CITY OF ST. PETERSBURG, FLORIDA  
PLANNING AND DEVELOPMENT SERVICES DEPARTMENT  
URBAN PLANNING AND HISTORIC PRESERVATION DIVISION

### Community Planning and Preservation Commission Certificate of Appropriateness Request

Case No.:	21-90200092
Address:	3200 8 <sup>th</sup> Ave. N.
Legal Description:	KENWOOD SUB BLK 17, LOT 1 & E 5FT OF LOT 2
Parcel ID No.:	14-31-16-46350-017-0010
Date of Construction:	1949
Local Landmark:	Kenwood Section – Northwest Kenwood Local Historic District (18-90300008)
Owners:	Rachel L. Freeman and Joseph R. Warpinski
Request:	Request for the approval of a Certificate of Appropriateness for the installation of a front, side, and rear fence at a corner property in a local historic district

Figure 3: Proposed location of four-foot picket fence (indicated by blue line), arbor/pergola (indicated by yellow square), and – six foot privacy fence (indicated by red line)

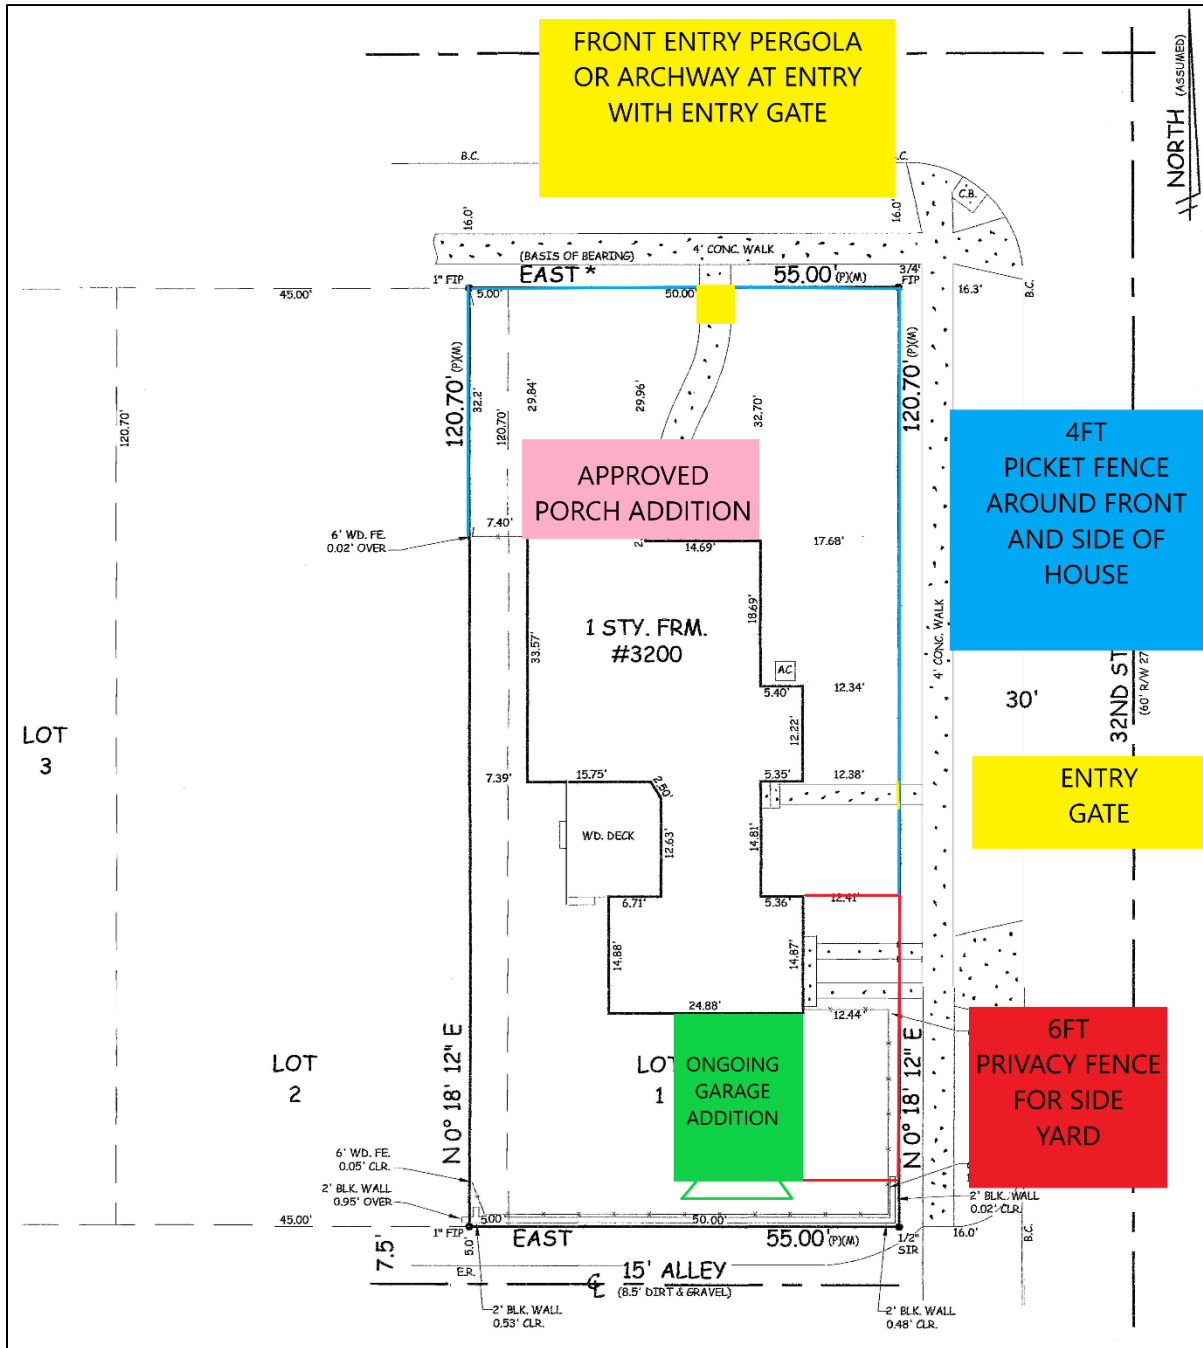
Because a low fence (whether wood or vinyl) with high transparency will not obscure views of the residence (which is the contributing resource at the property) and is easily reversible, staff considers the proposal for a front yard fence to be partially consistent with this criterion.

The proposed arbor at the entrance to the front yard is not consistent with designs common to the historic period to staff's knowledge.

The privacy fence, though now a common design in the subject district, was also not typical during the historic period. Although placed in the street side yard, it is proposed to be set far back from the residence's façade, allowing the building's historic side elevation to remain visible from elsewhere in the district.

So long as the privacy fence is set back from the sidewalk line to comply with Zoning requirements for fences over 4 feet, staff considers this to be an appropriate placement for a rear yard fence at a corner property.

Staff recommends the height of the picket fence be lowered from 4 feet to 3 feet.

1. The front and side-yard picket portion of the fence be no more than 3 feet in height.
2. The arbor at the front entrance be replaced with a standard entrance gateway.
3. All vinyl fencing materials will feature a matte finish.

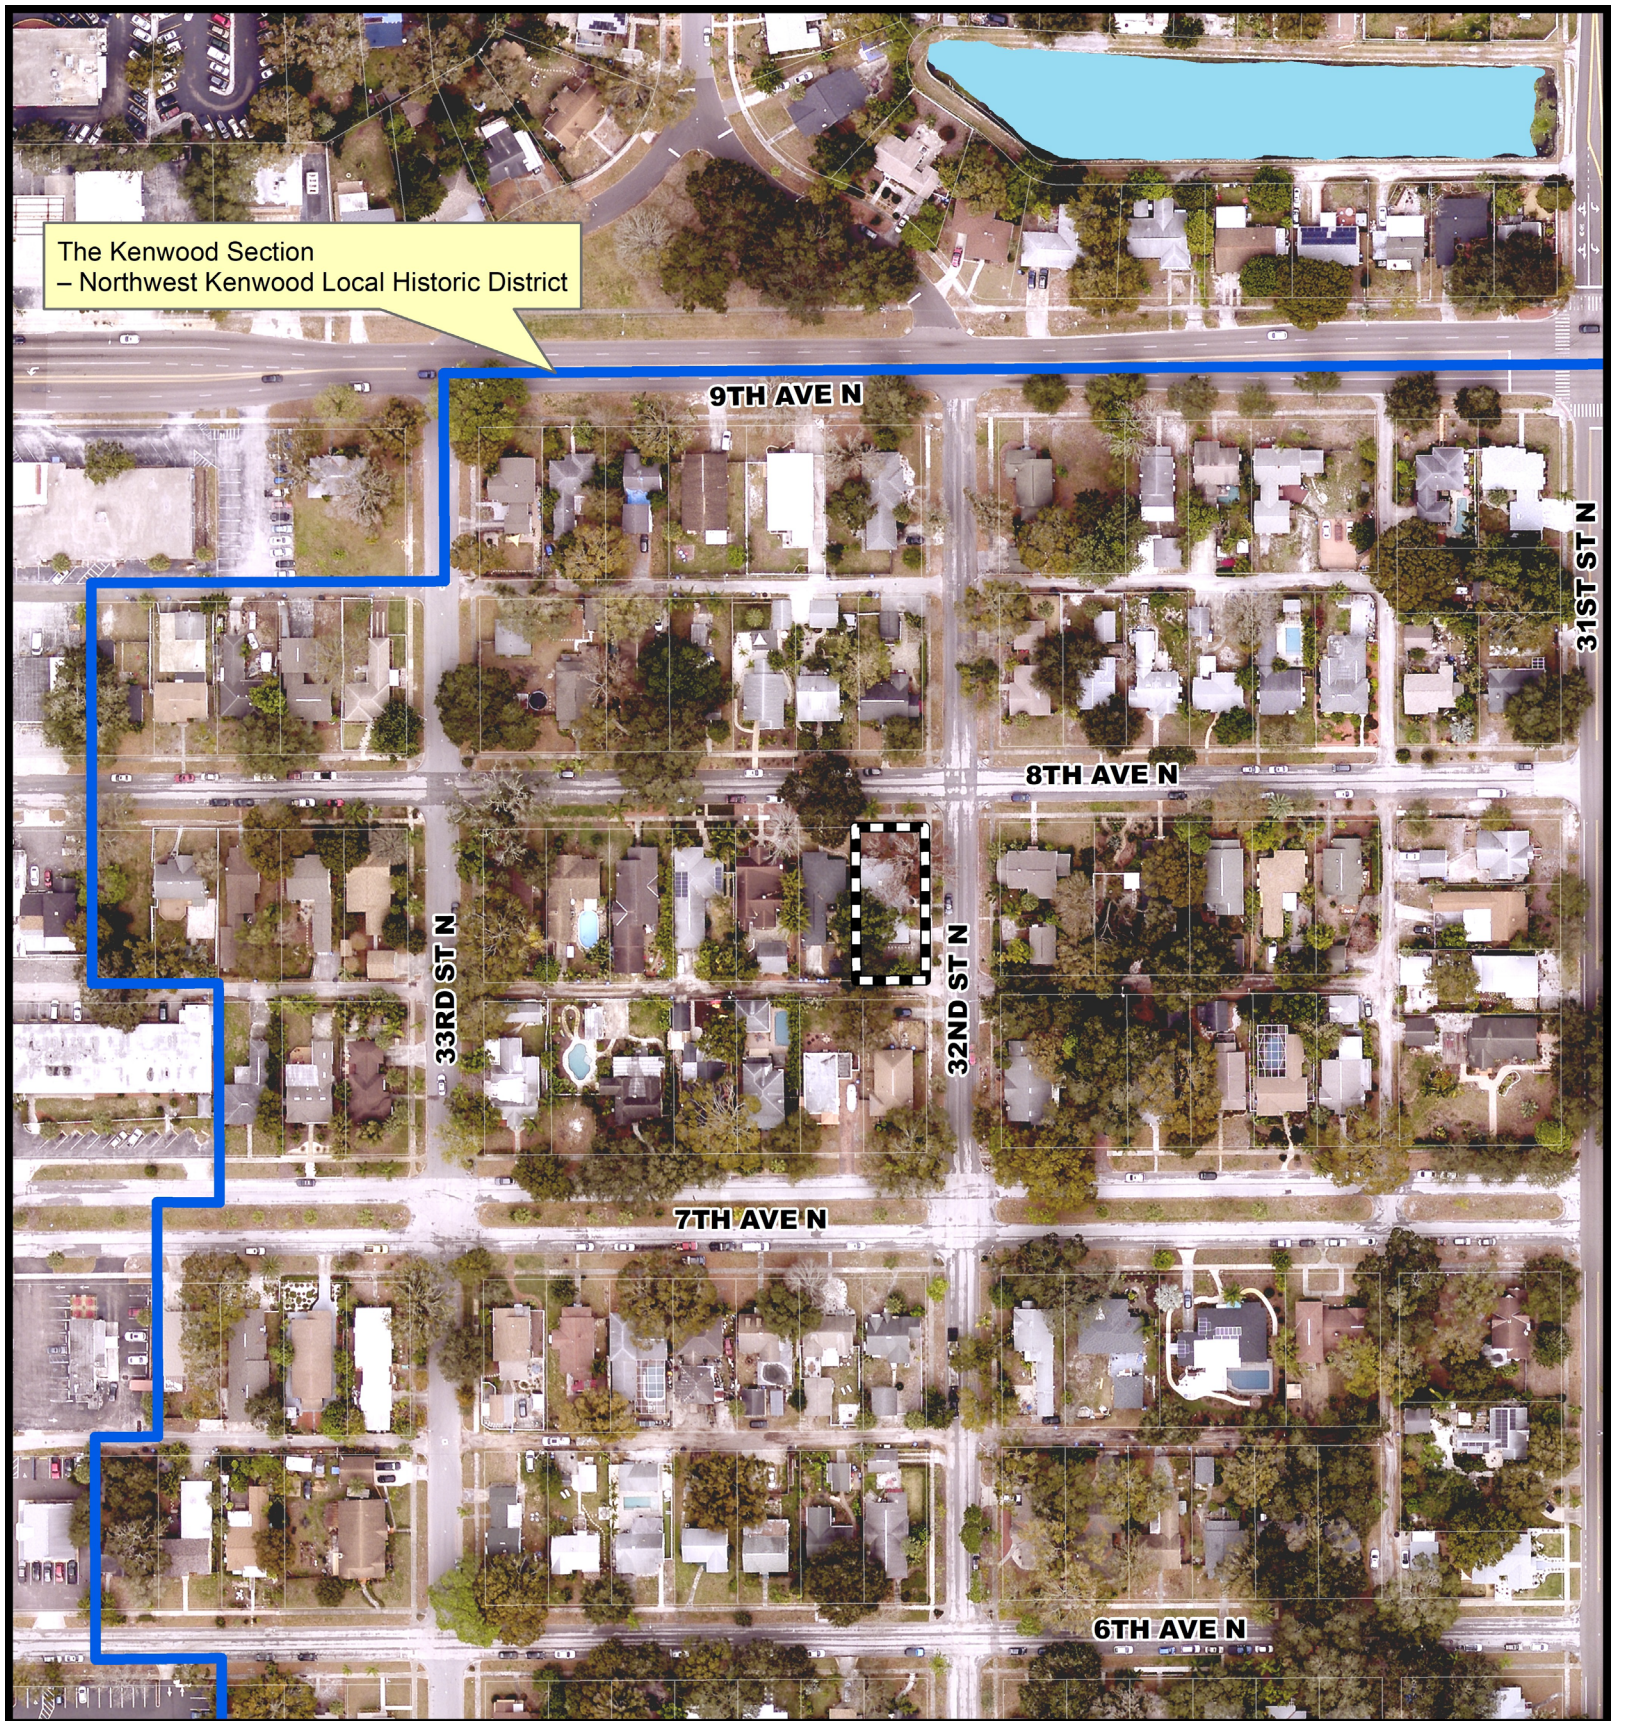
1. The rear fence is located such that it is outside of the visibility triangle.
2. The front/side fence is partially located within the corner visibility triangle. Approximately 12 feet along the east side and 12 feet from the corner along the north side lie within the visibility triangle. The fence in this area must be no higher than 36 inches. No vegetation within the visibility triangle is allowed at a height greater than 36 inches.
3. A condition of approval needs to be provided to remove and replace the driveway and driveway apron along 32<sup>nd</sup> St N with sod and to replace the curbing to its original state.
